PROPOSED CHANGE RTS 124 TO
THE DUANE ARNOLD ENERGY CENTER
TECHNICAL SPECIFICATIONS

The holders of license DPR-49 for the Duane Arnold Energy Center propose to amend Appendix A (Technical Specifications) to said license by deleting current pages and replacing them with the attached, new pages. A list of the affected pages is included.

The current DAEC Technical Specifications do not allow plant operation beyond 24 hours if an idle recirculation loop cannot be returned to service. The ability to operate at reduced power with a single loop is highly desirable from availability/outage planning standpoint in the event that maintenance or component inavailability renders one loop inoperable. Such events have occurred three times during the current cycle and have caused the licensee to apply for temporary amendments, sometimes on an emergency basis. Therefore, the holders of this license propose that the Technical Specifications be revised as indicated in the attached pages to allow single-loop operation. Supporting analysis is given in NEDO-24272, which is reference 11 on P. 3.12-11 and a copy is enclosed.

FIGURE 3.12-2

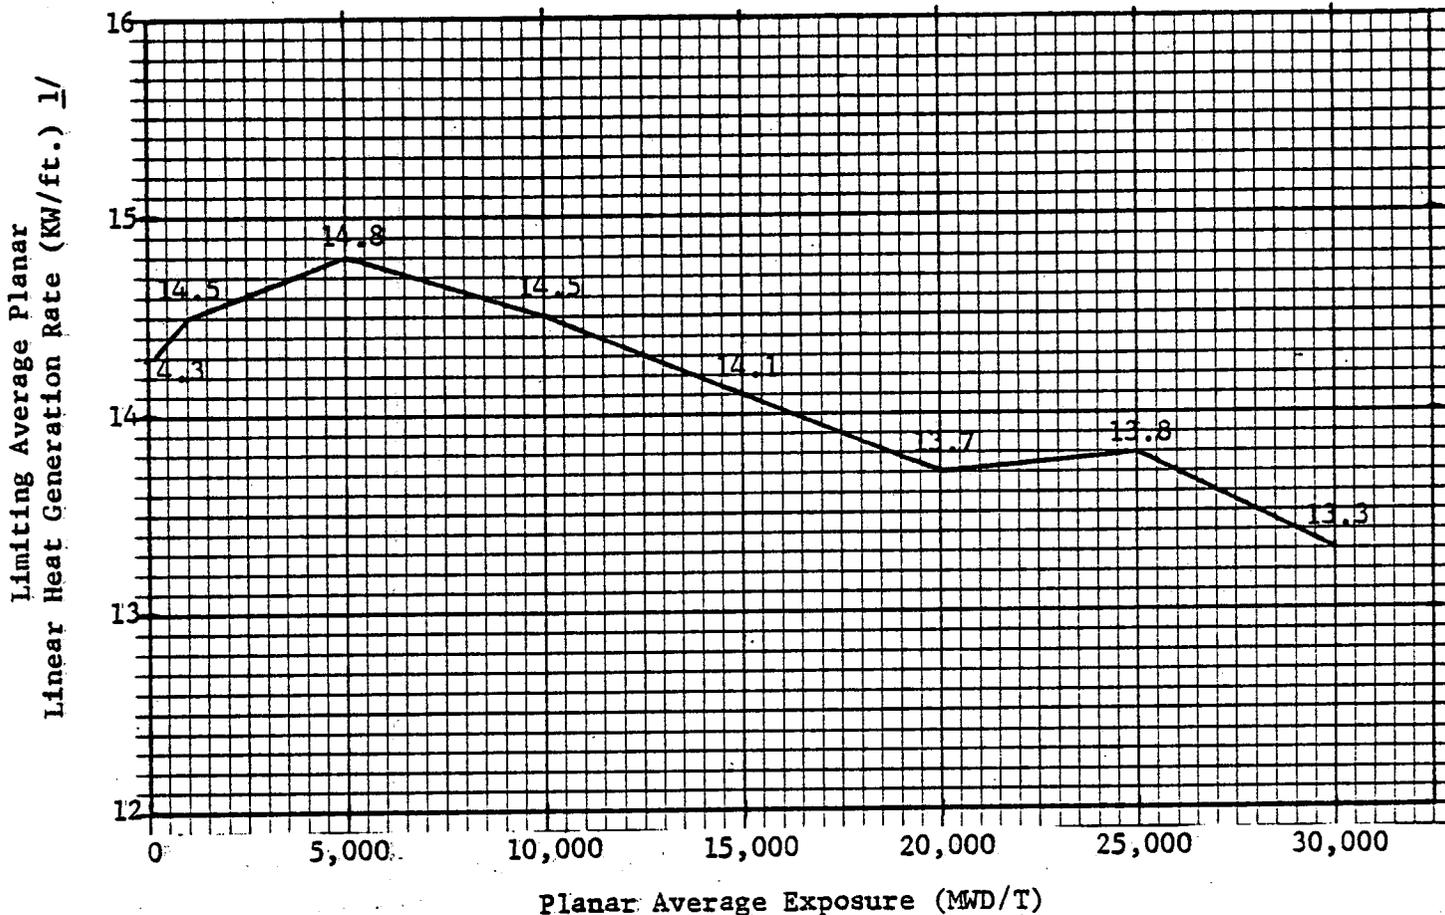
1/ When core flow is equal to or less than 70% of rated, the MAPLHGR shall not exceed 95% of the limiting values shown. Values shown are for two recirculation loops. Reduction factors for one recirculation loop were derived in Reference 4.

FIGURE 3.12-3

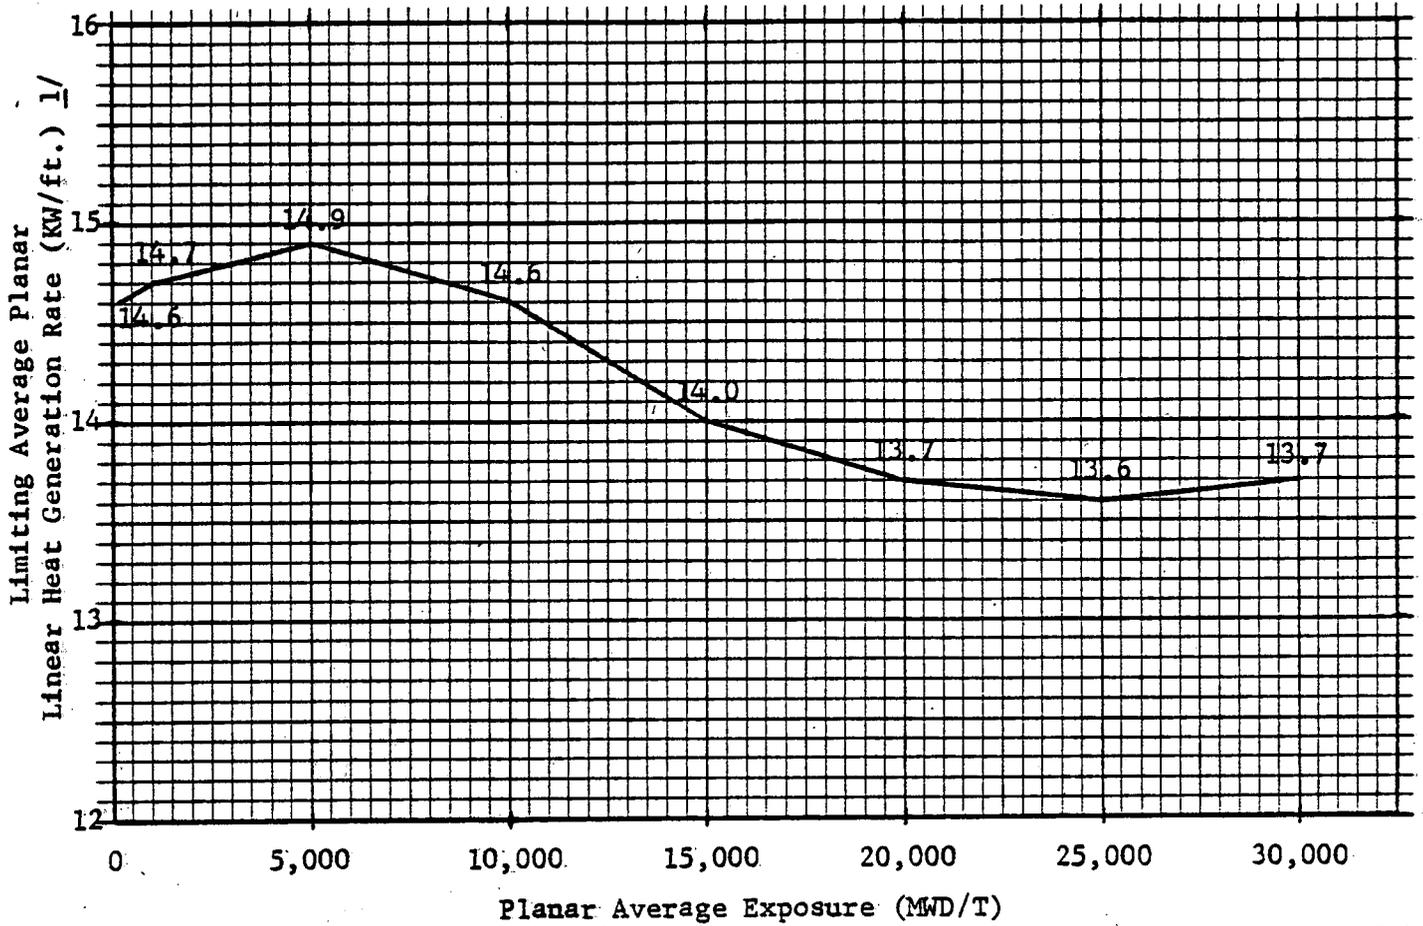
1/ When core flow is equal to or less than 70% of rated, the MAPLHGR shall not exceed 95% of the limiting values shown. Values shown are for two recirculation loops. Reduction factors for one recirculation loop were derived in Reference 4.

FIGURE 3.12-4

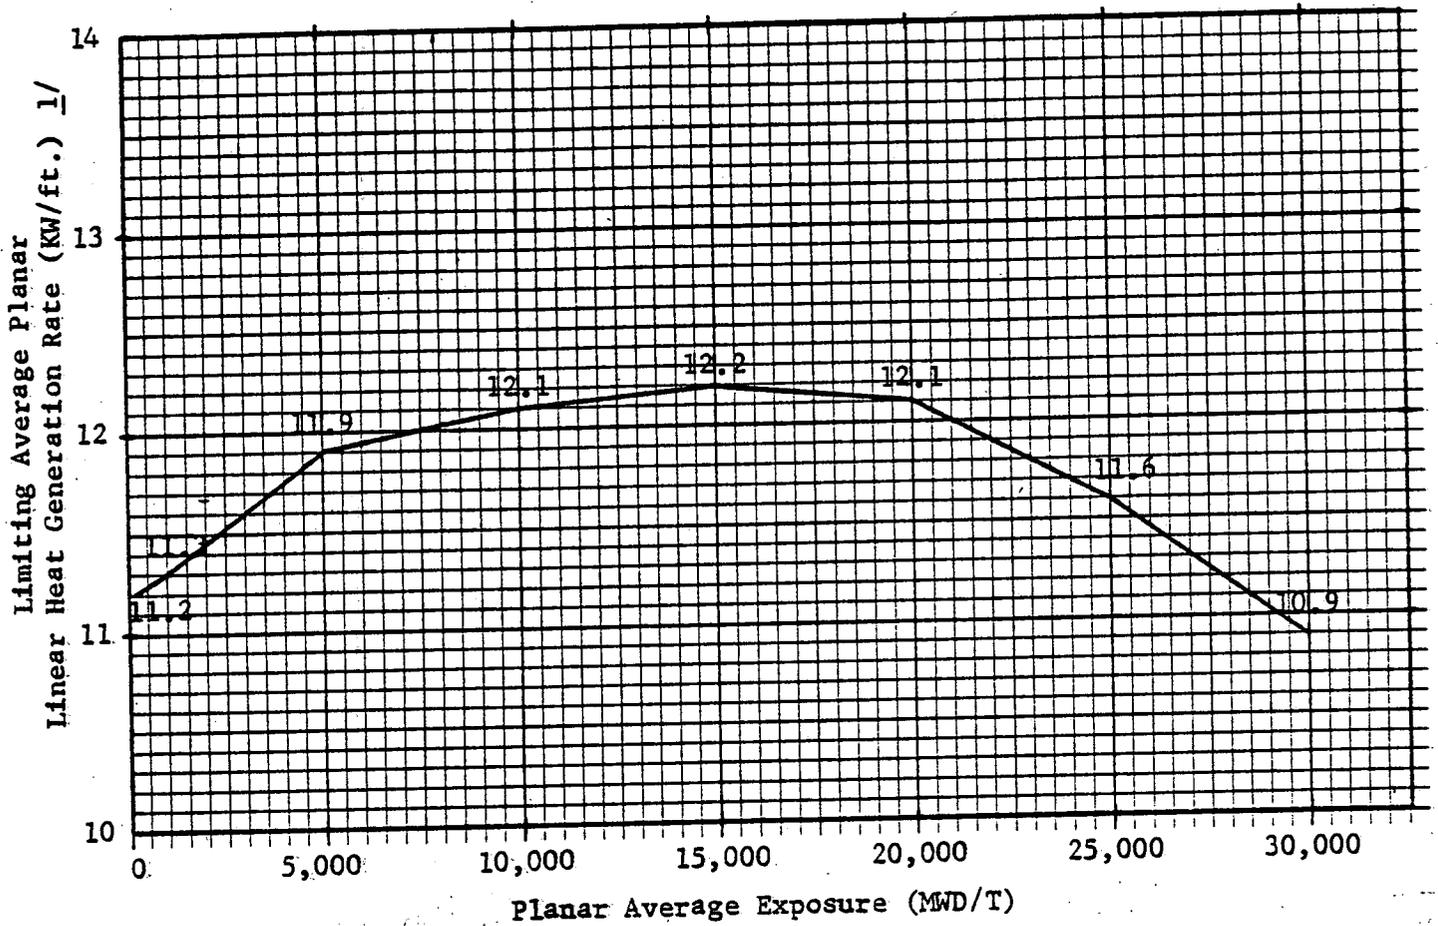
1/ When core flow is equal to or less than 70% of rated, the MAPLHGR shall not exceed 95% of the limiting values shown. Values shown are for two recirculation loops. Reduction factors for one recirculation loop were derived in Reference 4.

FIGURE 3.12-5

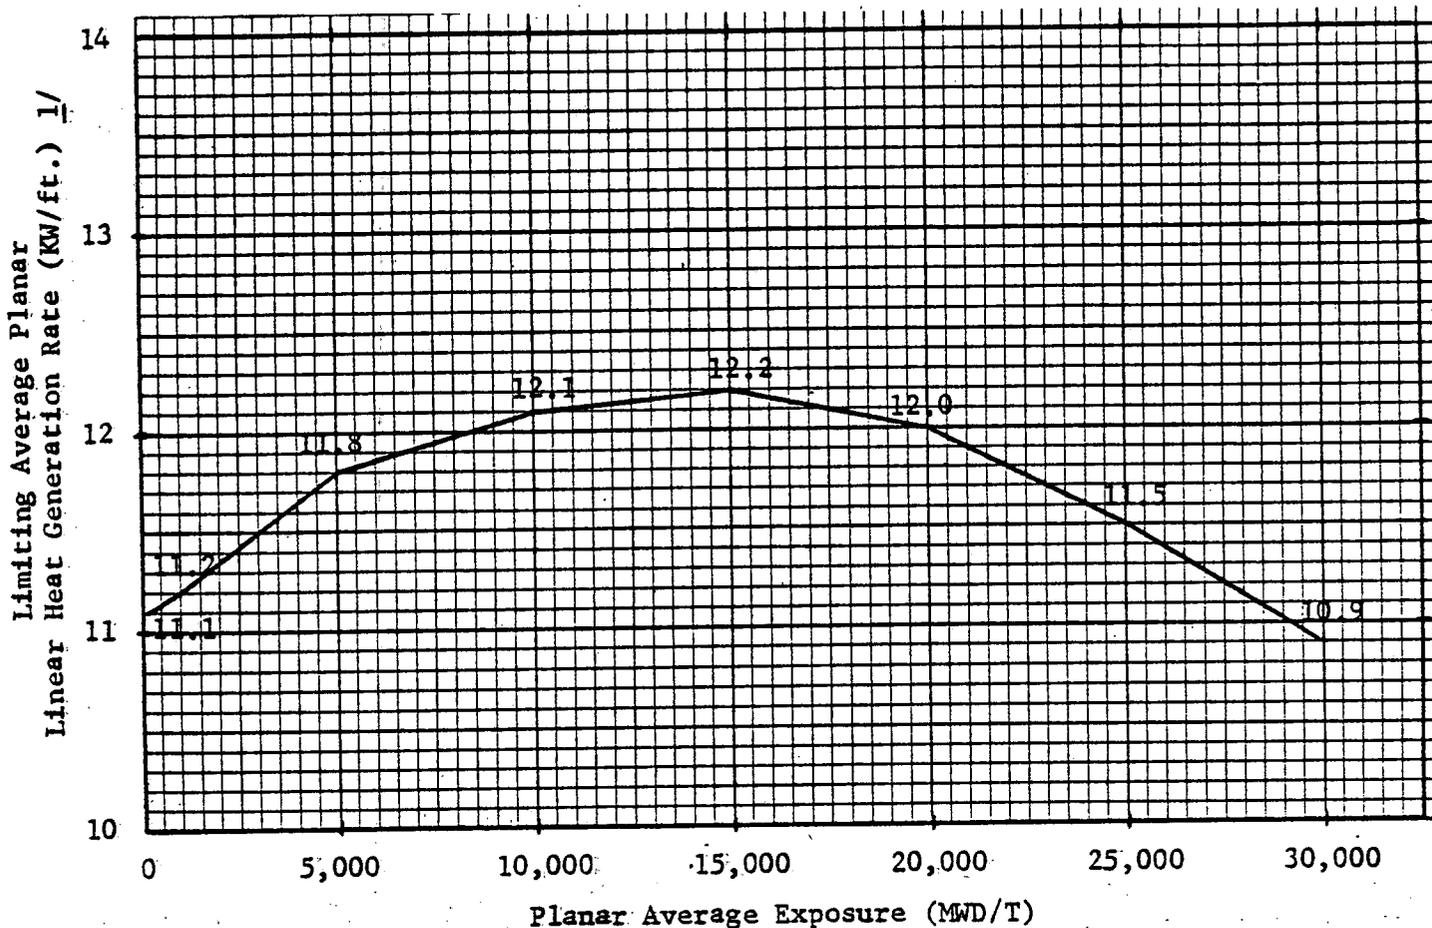
1/ When core flow is equal to or less than 70% of rated, the MAPLHGR shall not exceed 95% of the limiting values shown. Values shown are for two recirculation loops. Reduction factors for one recirculation loop were derived in Reference 4.
